Department of Public Works Riverwalk Site Review Overlay Zone

For the renovation of the Milwaukee Repertory Theater at 108 East Wells Street

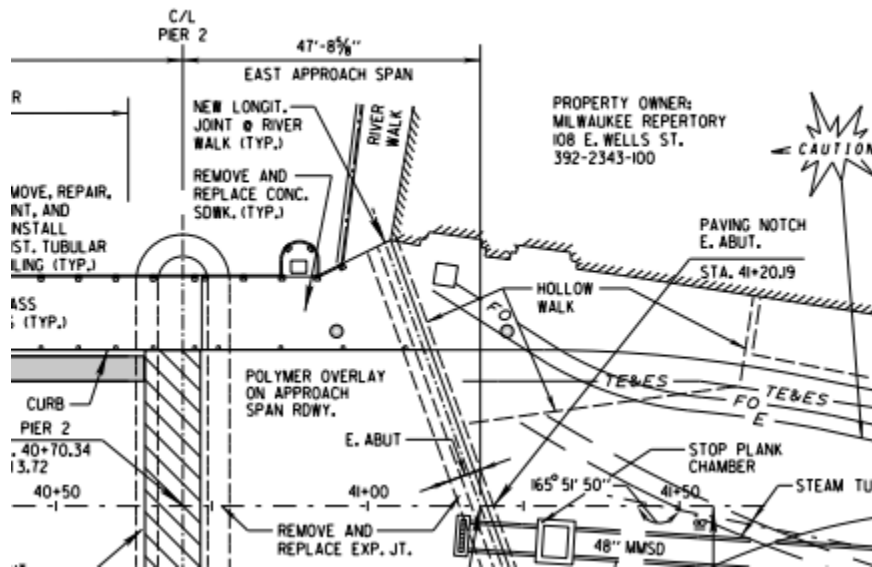
The proposed modifications to the existing curb cut shown in the submittal are in conflict with an existing We Energies vault:

In 2017 the City of Milwaukee and Wisconsin Department of Transportation rehabilitated the Wells Street lift bridge. As part of this work, the City coordinated with We Energies Steam and they replaced the top of the vault structure, installed new waterproofing and the sidewalk topping with mountable curb. This work was coordinated with the Rep facilities manager at the

time. At that time, it was determined that an ADA accessible ramp with no curb is technically infeasible over the vault given the elevation of the top of the steam facility. Therefore, the crossing was constructed at the current location.

In addition, the bridge expansion joint and header would be in conflict with the proposed modifications. Below is a clip of the bridge plans for this corner showing that the vault is directly below the proposed ADA ramp and showing the back of the abutment location and bridge expansion joint.

No modifications can be made to the existing layout of the sidewalk as it would impact We Energies Steam and the City's bridge approach expansion joint.

Street Lighting Comments for the Proposed Milwaukee Repertory Theater Work:

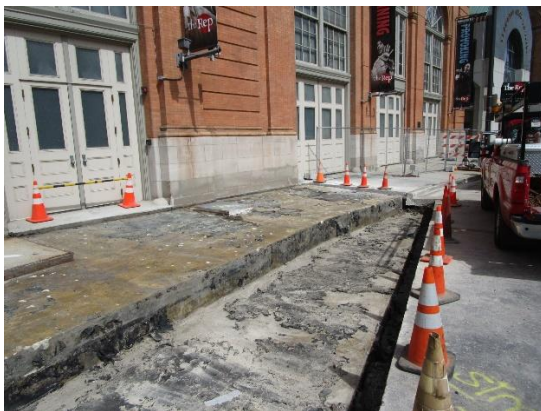
- Located next to the Milwaukee River the proposed modification to existing curb cut sits on top of hollow walk that has utilities in the structure below.
- Located next to the Milwaukee River street lighting has conduit and cabling that runs just below the sidewalk and above the roof deck of the hollow walk.
- At the main entrance along the north curb of E. Wells St. street lighting has facilities located behind the curb that will be impacted with the proposed curb dive-in.

- The street lighting pole located on the west end of the main entrance falls within the work limits has a camera mounted on the pole for the Wells St. Bridge that needs to remain in service.
- There is existing hollow walk in front of the Pabst Theatre on the east end of the main entrance that falls within the proposed curb dive-in work limits.
- Any proposed bollards need to be installed within the property and not in the right of way.
- The harp poles along the Milwaukee River do not belong to the City of Milwaukee Street Lighting, instead they are the responsibility of the Riverwalk Assoc.
